Product Change Notification

113211 - 00

Change Notification #: 113211 - 00
Change Title: Intel® Server System R2308GZ4GC
PCN 113211-00, Product Design
Update Resistors and Capacitors
Date of Publication: August 20, 2014

Figure 1. Component Locations for the 2U Riser Spare A2UL8RISER

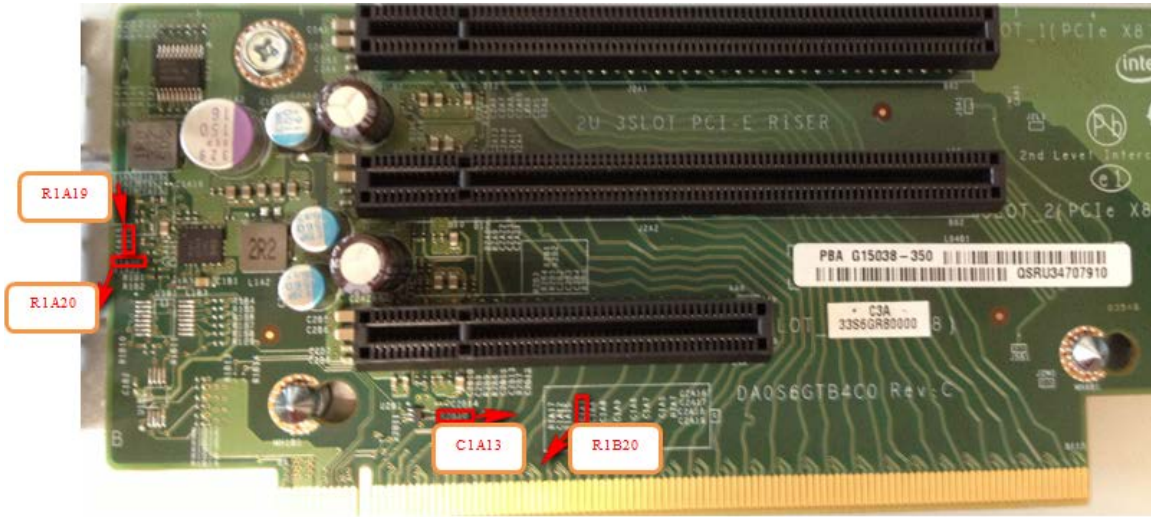
Update the following resistors and capacitor (see Table 1 and Figure 1) on the 2U PCIe Riser Spare A2UL8RISER to make an improvement to support a higher 3.3 Voltage Regulator startup over current. Before this change, the Voltage Regulator on the riser card may not be able to turn on when the total current drawn is more than 5A current. After this change, the Voltage Regulator on the riser card can support more than 10A current.

Component	Location	Pre-change	Post-change
Resistor	R2B10	10.0 kOhm	3.65 kOhm
Resistor	R1A20	0 Ohm	30 Ohm
Resistor	R1A19	40.2 kOhm	20 kOhm
Capacitor	C1A13	10 pF	120 pF
